Re: St. Lucie Plant Unit 1
Docket No. 50-335
Renewed Facility Operating License No. DPR-67

Response to NRC Electrical Engineering Branch Request for Additional
Information Regarding Extended Power Uprate License Amendment Request

Response to NRC Electrical Engineering Branch Request for Additional Information Regarding Extended Power Uprate License Amendment Request

(Figure 2.3.1-1 of Attachment 5 of the LAR)

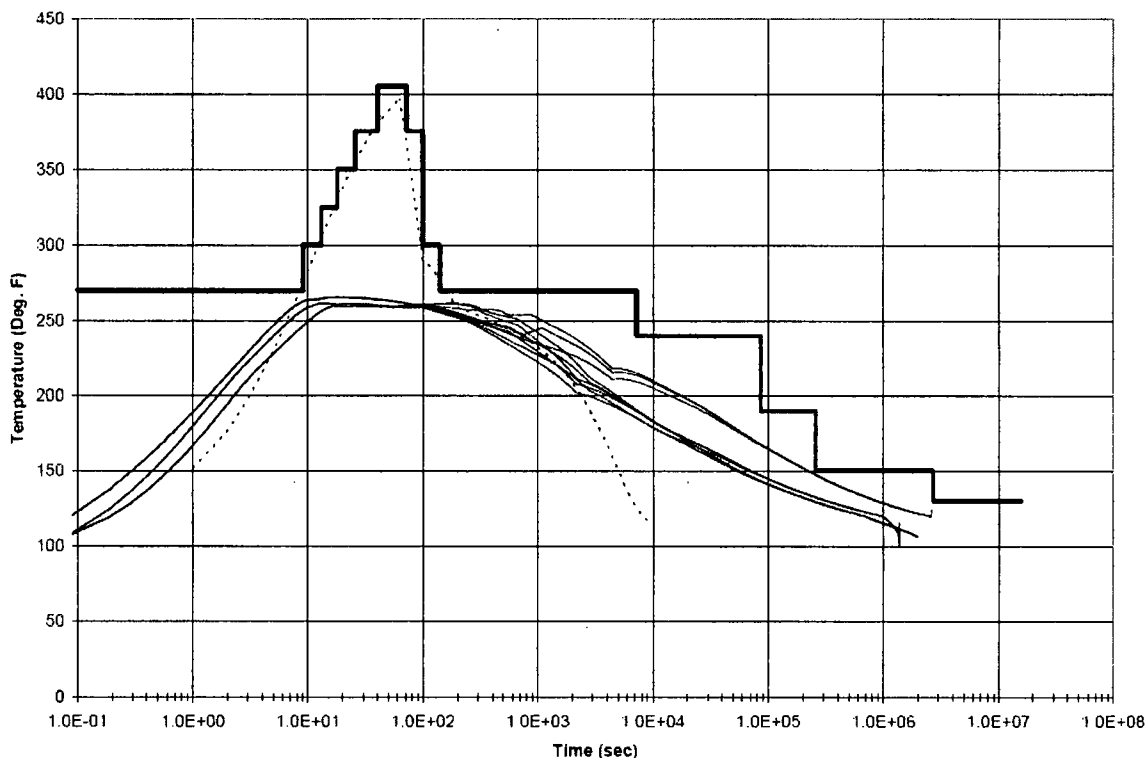
Figures 2.3.1-1 and 2.3.1-2, in Attachment 5 of the LAR, show the Unit 1 Containment LOCA and MSLB Accident Temperature and Pressure Profiles vs. Plant EQ Profiles of electrical equipment. The profiles in these figures do not appear to have the minimum EQ margins required per IEEE 323-1974. Provide justifications for apparent lack of margins. Provide discussion of the margins in the pre-EPU and post-EPU stages.

Figure 2.3.1-1 (shown above) shows the containment loss of coolant accident (LOCA) and main steam line break (MSLB) Accident Temperature Profiles vs. Plant EQ Profiles of electrical equipment. The curves provide visual indication of implemented margin from the onset of the accident for the EPU case. There are two accident types depicted, a short term (MSLB) and long term (LOCA).

The MSLB curve is depicted by a dotted line and is initially shown to be bounded by the bold dark curve. However, as can be seen, the IEEE 323-1974 recommended margin does not appear to be met. The margin and qualification is accomplished by a thermal lag analysis. The thermal lag analysis demonstrates (analytically) that the internal temperature of the equipment never exceeds the EQ temperature of record for the LOCA analysis (bold curve without the excursion portion).

For EPU, the LOCA curves are bounded by the EQ profile (bold curve without the excursion) with margin and satisfies the current licensing basis. The intent of the IEEE 323-1974 recommended margin was to ensure the peak accident values were compared to the components qualification test value for the parameters of concern.

The pre-EPU MSLB and LOCA were handled in a similar fashion as to that discussed for the EPU conditions
